2018/01/31

MAR/FR501 series Bonnet Change Notification

MAR501 series example :

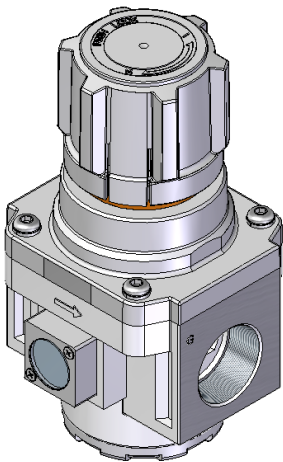
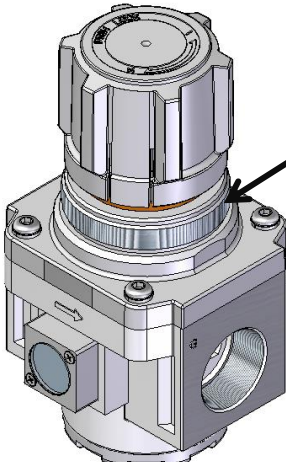
In response to market demand, bonnet parts provide screw design that can be attached to the machine panel.

Before	After
	 <p>External thread M62x1.5</p>
